AQUALLIANCE

BDCP/WaterFix Comments
Ryan Wulff, NMFS
P.O. Box 1919
Sacramento, CA 95812
Via Email to: BDCPComments@icfi.com

Subject: Comments on the Supplemental Draft Environmental Impact Statement and Partially Recirculated Draft Environmental Impact Report (“SDEIS/RDEIR”)

Exhibit 10.7

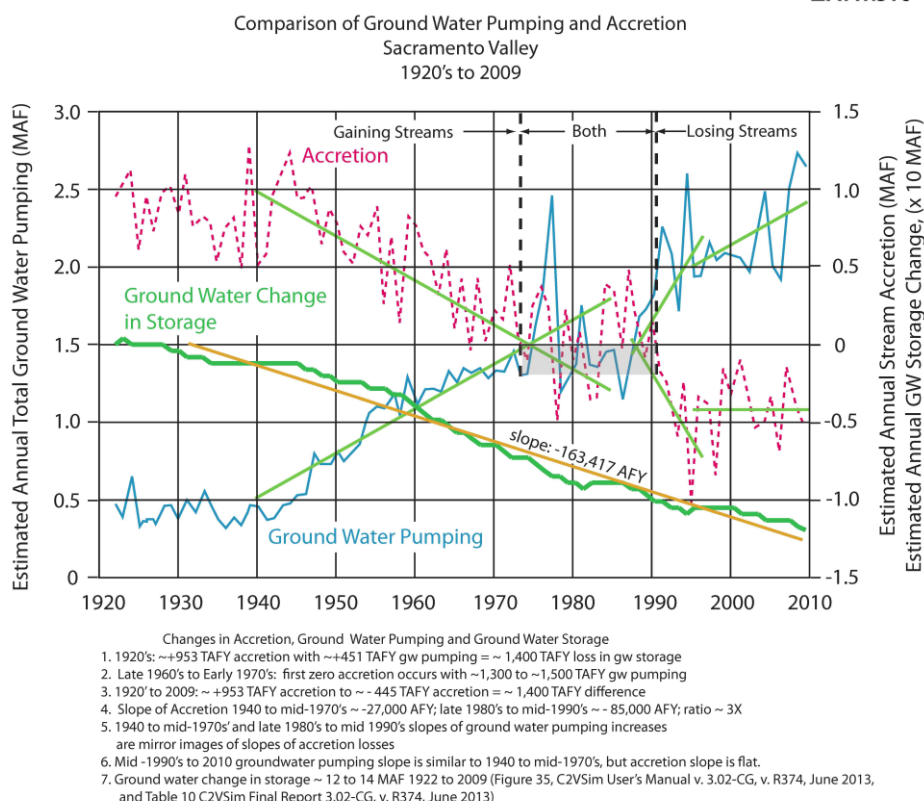
The simulated groundwater pumping graph in NCWA Figure 3-22 and stream accretion graph in NCWA Figure 3-24 were combined into one graph by scaling and adjusting their axes (Exhibits 10.7). The vertical scales of these two graphs were adjusted so that a zero value of stream accretion aligned with 1.5 million acre-feet (MAF) of annual groundwater pumping. This alignment was done to reflect the fact that in the early 1920s, groundwater pumping was approximately 0.5 MAF per year (MAFY) while stream accretion was approximately 1.0 MAFY. As shown in the combined graph, stream accretion generally decreases at approximately the same rate as groundwater pumping increases. Thus, at a point of no appreciable groundwater pumping, pre-1920s, the total long-term average annual stream accretion was likely 1.5 MAF, based on the C2VSim simulations.

Drawn on top of the stream depletion and groundwater pumping graphs are several visually fit, straight trend lines. These lines, which run from 1940 to the mid-1970s and the late 1980s to mid-1990s, are mirror images reflected around the horizontal 0 accretion axis. Information provided at the bottom of the composite graph was taken from NCWA Tables 3-7 and 3-8 (Exhibits 10.5b and 10.5c). The slope of the trend line from 1940 to the mid- 1970s is approximately (+-)27,000 AFY, and (+-)85,000 AFY in the late 1980s to the mid- 1990s; a 3-fold increase in slope. After the mid-1990s the slope of groundwater pumping flattens to be similar to that of the 1940s–mid-1970s, while the stream depletion line became almost flat, ie., no change in rate of accretion. The reason for the stream depletion rate being flat is unknown, but there are several factors that could contribute to a fixed rate of stream accretion.

First, after depleting 1.5 MAFY from the Sacramento Valley streams, the surface waters may not be able to provide much more, at least no increase to match the pumping. Second, this may also be a consequence of the model design because the number of streams simulated was limited. Third, the model's grid may not extend out far enough to encompass all of the streams that contribute to groundwater recharge. More information on the areas of where streams gain and lose in the Sacramento Valley is needed to determine if there are any sections of stream, gaining or losing, that might still have the ability to interact at a variable rate in the future, ie., during and after the 10-year groundwater substitution transfer project.

A third graph is drawn on the composite accretion-pumping graph in Exhibit 10.7 that shows the C2VSim simulated cumulative change in groundwater storage for the Sacramento Valley from 1922 to 2009. This graph was taken from Figure 35 of Brush and others, 2013b (Exhibit 10.4). A straight trend line with a negative slope of approximately -163,417 AFY is drawn on top of the third graph, which is the value for average annual change in storage from 1922 to 2009 given in Table 10 of Brush and others (2013a; Exhibit 6.3a) for the seven subregions of the Sacramento Valley. The selected graph of the cumulative change in groundwater storage is one of three available.

Additional review and analysis of the changes in groundwater storage in the Sacramento Valley is needed. Any additional review of changes in groundwater storage in the Sacramento Valley should consider the recent changes in groundwater elevations such as those shown in DWR (2014b) for WYs 2004 to 2014, and Figures 2-4 and 2-5 of NCWA, 2014b (Exhibit 10.8 and 10.9), as well as other studies such as the support documents for the regional IRWMPs. [Supporting material found in AquAlliance's Tables 1 and 2 above.]
